EXPLANATORY ADDENDUM

Issue date: 27 November 2019
Issued by: Alex Lohrisch
Client: Goodman Property Services (Aust) Pty Ltd
Reference: MEM002-01-15-272-Mod Report Explanatory Addendum.docx
Subject: SSDA 7348 EXPLANATORY ADDENDUM TO MOD 2 CIVIL ENGINEERING REPORT (REV 11 SEPT 2019)

1.0 Precinct 1 Layout and Road 2 Removal

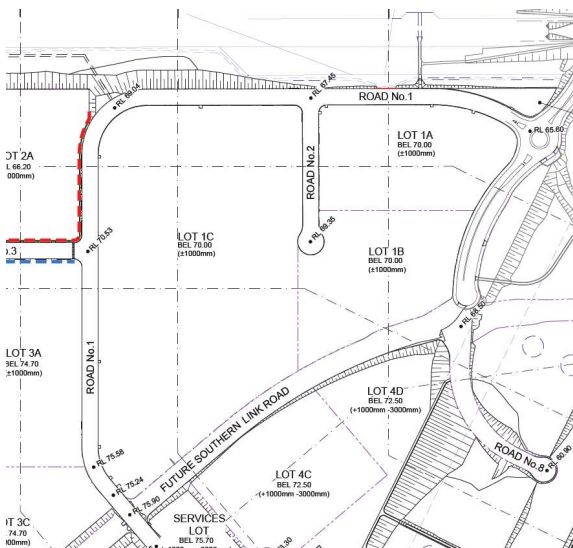
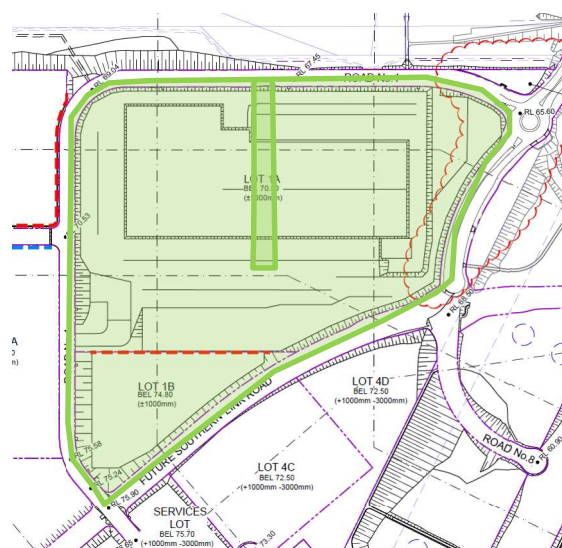
Precinct 1 has been modified to suit the revised on-lot building layout, which includes the removal of Road 2.

2.0 Earthworks and Retaining Walls

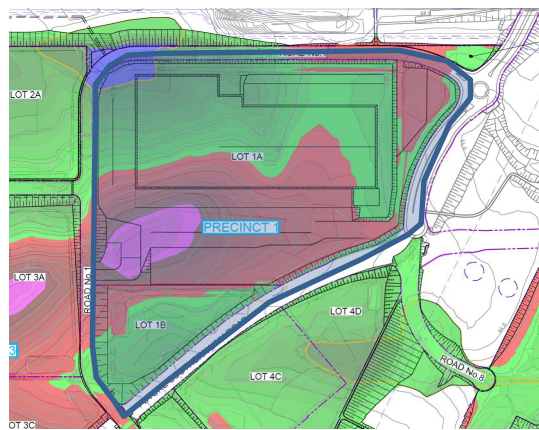
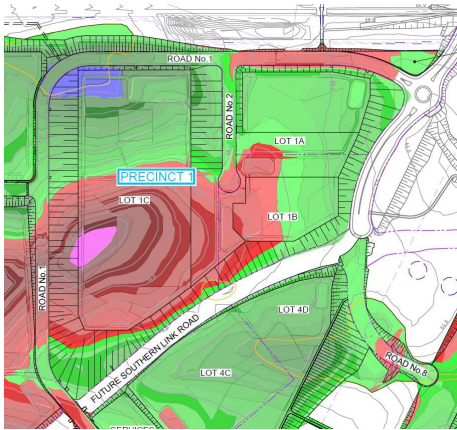
As a result of the changes associated with item 1.0 above, earthworks across Precinct 1 have changed.

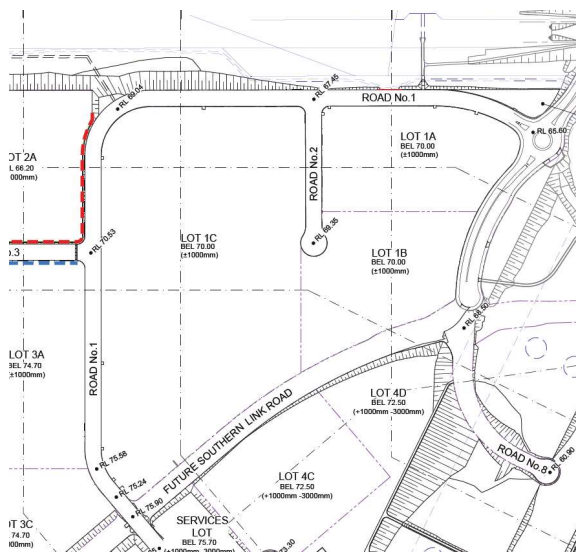
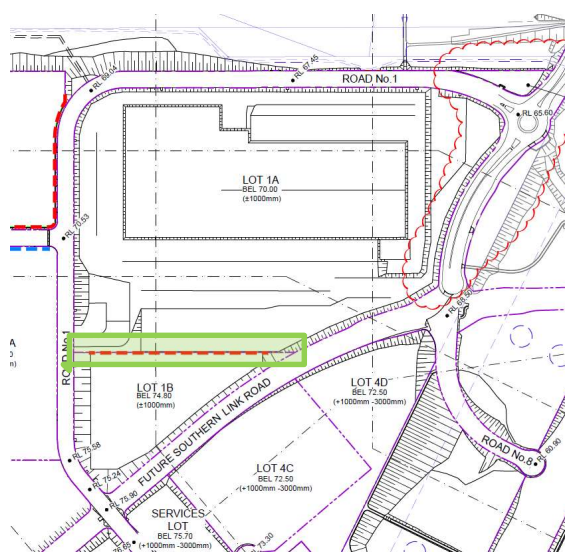
A new retaining wall (Retaining wall 20) has been added between Lot 1A and 1B to address the level differences between Lot 1A and Lot 1B.

3.0 Proposed Boundary Adjustments – Road 1 and WNSLR Intersection

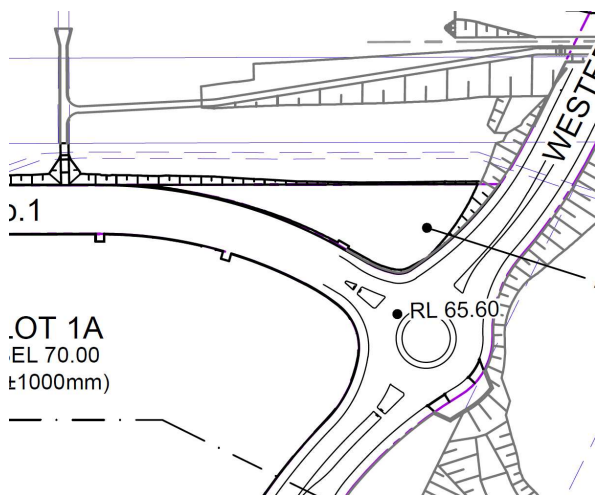
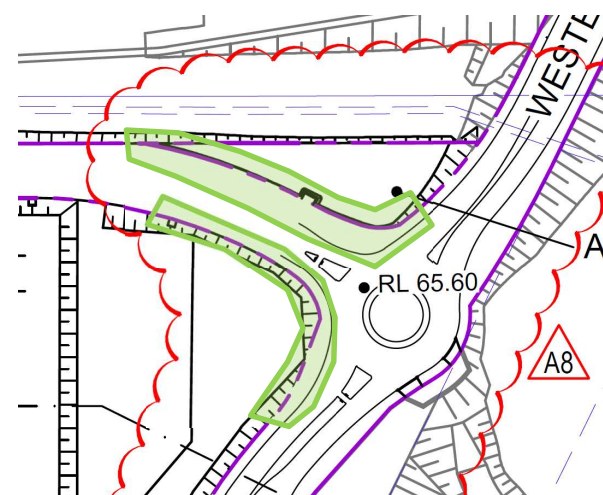
The proposed boundaries at the Road 1 and WNSLR intersection have been modified. These modifications have been completed to increase the road reserve area, so to facilitate (if required), future upgrades of the intersection without, or at least, minimise future land acquisition and services adjustments/relocations.

4.0 Stormwater in Road 1

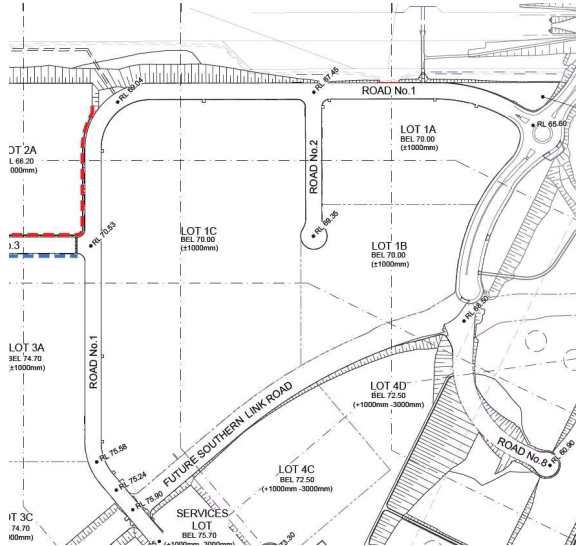
The stormwater pit and pipe design within Road 1 has been modified to suit the revised Precinct 1 lot layout. Generally, this has involved upsizing pipework along the southern/eastern side of Road 1 to account for the stormwater outlet point for Lot 1B.
